AIR RESOURCES BOARD

Final Statement of Reasons for Rulemaking
Including Summary of Comments and Agency Response

PUBLIC HEARING TO CONSIDER THE ADOPTION OF A
REGULATION TO REDUCE METHANE EMISSIONS FROM
MUNICIPAL SOLID WASTE LANDFILLS

Public Hearing Date: June 25, 2009
Agenda Item No.: 09-6-3

Figure 1. Comparison of SCAQMD Landfills with non-SCAQMD Landfills

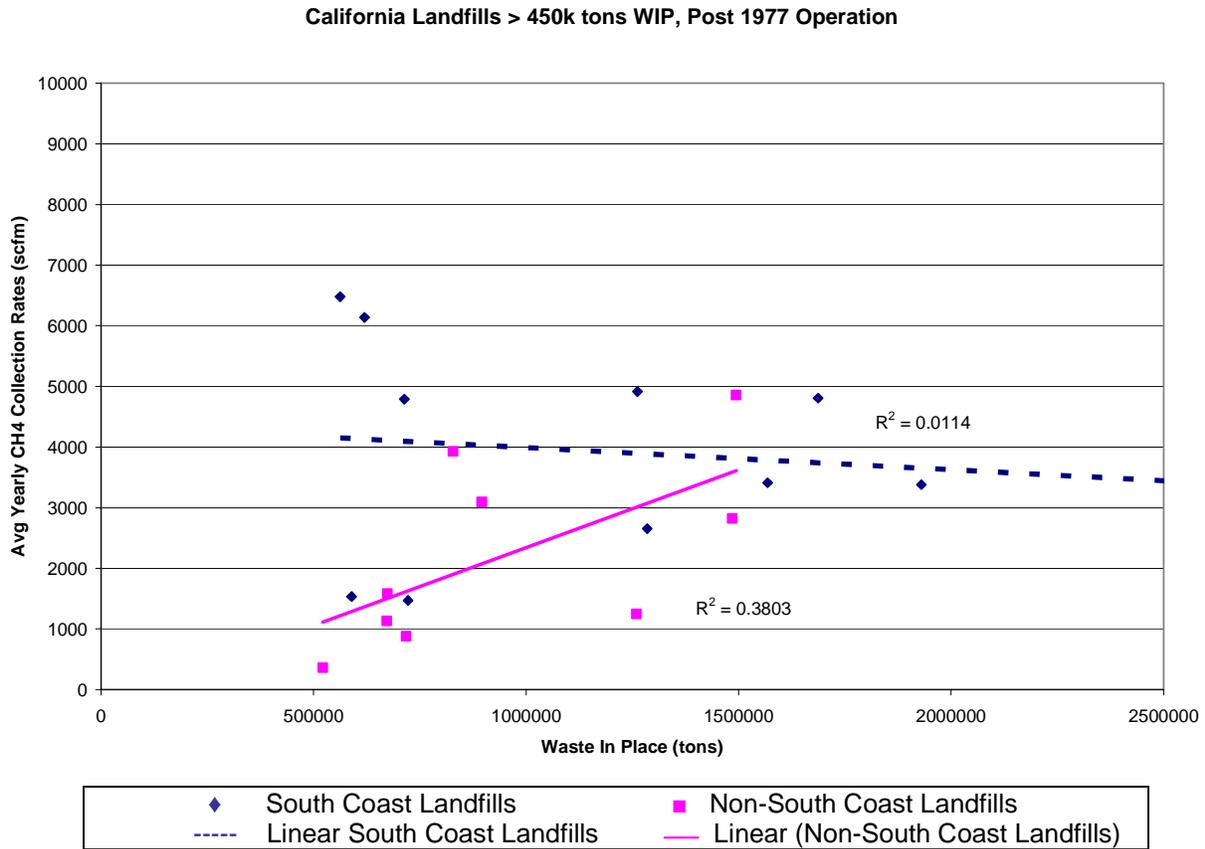
- 33. Comment:** We recommend that ARB staff focus on analyzing the differential gas collection rates between landfills that are under SCAQMD jurisdiction and those located elsewhere in the state. (CAW)

Response: As suggested by CAW, ARB staff evaluated an alternative method for estimating the emission reduction benefits of the approved regulation by comparing existing site-specific methane collection rates for South Coast landfills, which are subject to requirements similar to the approved rule, with non-South Coast landfills. Staff used the methane volumetric flow rate before the destruction/control device as the measurement of the methane generation rate. Certain minimum site-specific data was needed for this approach including: landfill size, age, methane collection rates, amount of waste-in-place, and the presence of gas control systems. In most cases staff did not have site-specific data for moisture content or waste composition, so a 50 percent moisture content was assumed for all landfills.

Figure 1 shows that there is little correlation between waste-in-place and collection rate as shown by the low regression values of 0.0114 and 0.3803 for South Coast and non-South Coast landfills, respectively. The lack of correlation between waste-in-place and the collection rates raises concerns about using the small sample of gas collection rates to estimate the emission reductions from the adopted rule and the impact on collection efficiency.

The data suggests that, for landfills in the 500,000 to 1 million tons of waste in place range, enhanced monitoring, similar to the adopted rule, would more than double methane capture. However, in the 1 to 2 million tons of waste in place range, enhanced monitoring, similar to the adopted rule, would provide few additional benefits. This clearly suggest that an approach using only the difference between gas collection rates for landfills in the South Coast and those outside the South Coast cannot be used to reliably estimate the overall collection efficiency of the rule.

These shortcomings show that this alternative method, which is based on the single metric “methane collection rate,” cannot be used to estimate statewide emission reductions. In order to use this alternative method, a full range of site-specific data is needed. Unfortunately, the necessary site-specific data are not currently available and is unlikely to become available within the next few years. Accordingly, in absence of the necessary site-specific data, the modeling approach outlined in Chapter IV of the Staff Report to estimate statewide emission reductions is both reasonable and appropriate.
